United States Department of the Interior

Subject: United States Bureau of Reclamation (Reclamation) Permits 11308 and 11310
(Applications 11331 and 11332), on the Santa Ynez River, Cachuma Project – Settlement
Agreement

Proposed Modifications to WR-73-37 as amended by WR 89-18
Pertaining to Permits 11308 and 11310 (Applications 11331 and 11332)
of the
United States Bureau of Reclamation
For the Cachuma Project, California
as developed by:

Revised
USBR Exhibit 1
February 1, 2003

Attachment E – Relationship Between Percolation from Santa Ynez River from
Narrows through Floradale Avenue and Flow of Santa Ynez River at
Narrows

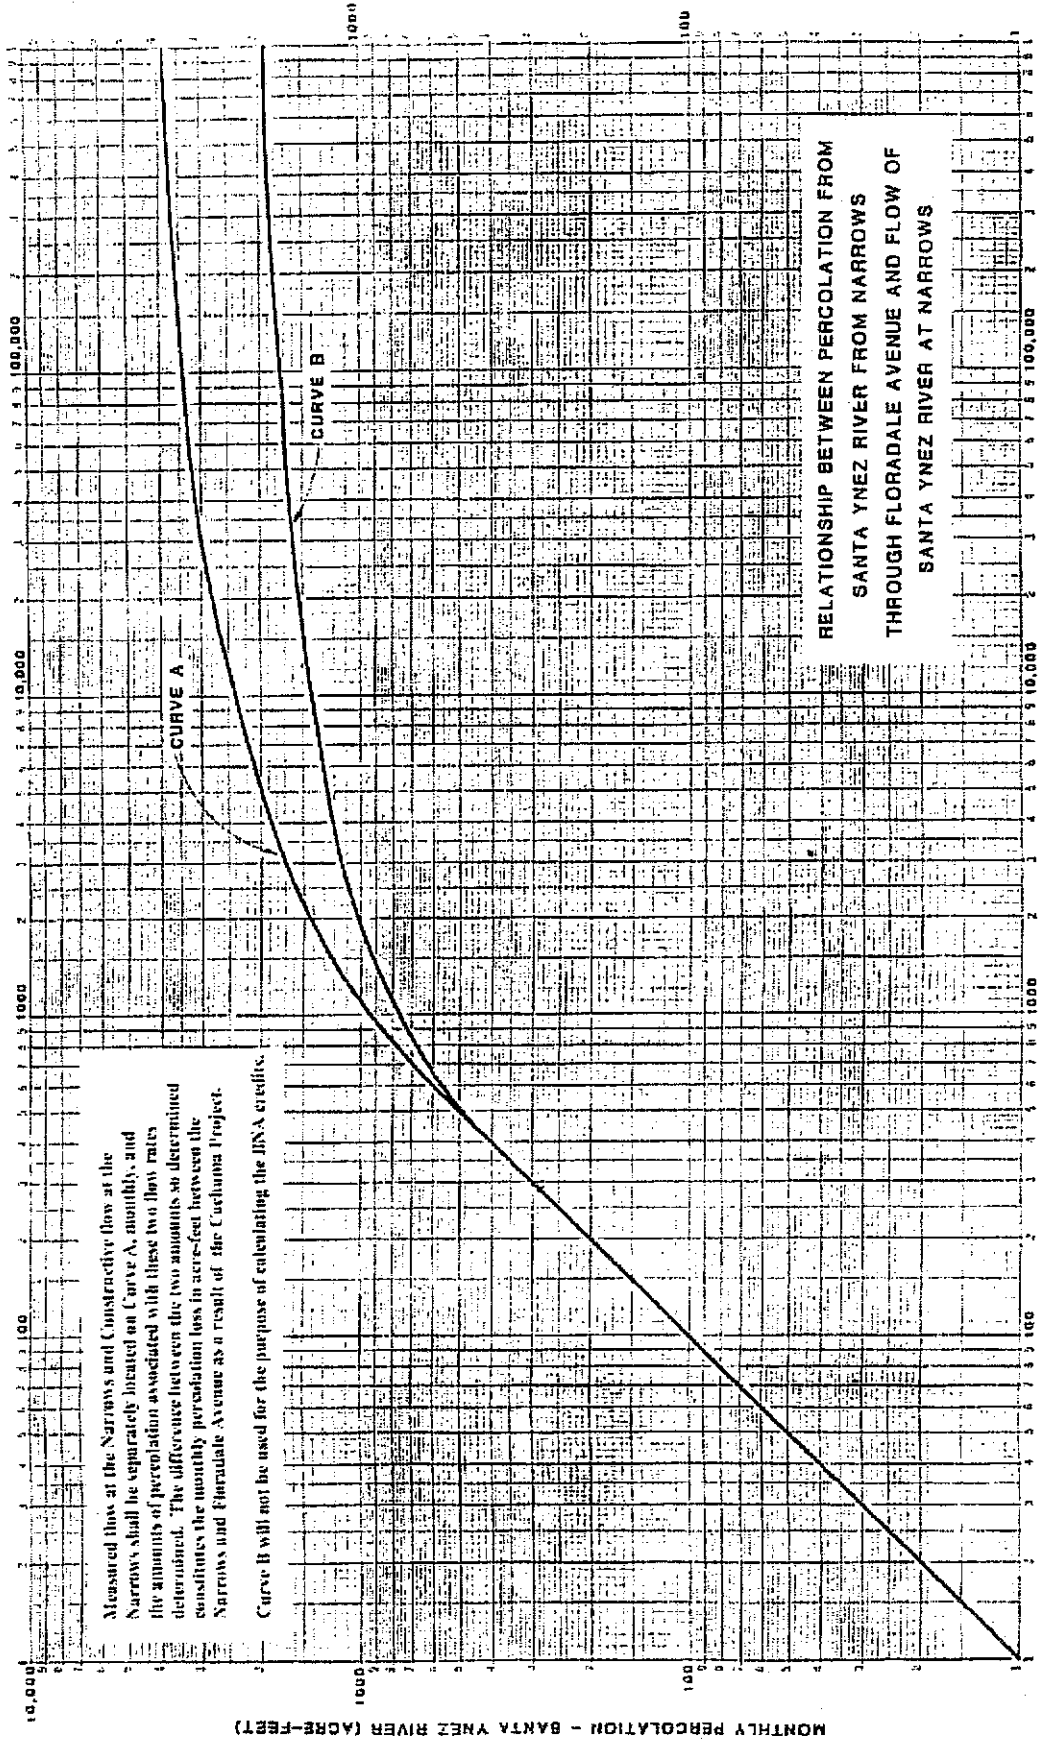
"(2.2.1) (Eliminated) ~~For a period of five years, which years shall include a range of surface flow conditions in the Santa Ynez River below the Narrows from high to low, the parties will make additional observations to permit more accurate calculations as to when Curve B, [the lower curve] as depicted on~~

~~USBR Exhibit 1, Attachment E, dated December 1988 shall be used in lieu of Curve A, [the upper curve] as depicted on said USBR Exhibit 1, Attachment E. During said observation period, Curve A [the upper curve] shall be used at all times. Any party may, after an adequate observation period has ended, seek an amendment of this order to establish the time and circumstances under which Curve B, [the lower curve] shall be used. Upon the effective date of the amendment the "below narrows" account credits for the five year period immediately preceding the amendment shall be recalculated using Curve B, [the lower curve] whenever appropriate, and adjustments to the "below Narrows" account shall be made. Any reductions in the "below Narrows" account resulting from such adjustments shall be spread equally over the five year period immediately following the effective date of the amendment, or such other period as the parties may agree to at the time.~~

Measured flow at the Narrows and Constructive flow at the Narrows shall be separately located on Curve A, monthly, and the amounts of percolation associated with these two flow rates determined. The difference between the two amounts so determined constitutes the monthly percolation loss in acre-feet between the Narrows and Floradale Avenue as a result of the Cochuma Project.

Curve B will not be used for the purpose of calculating the BNA credits.
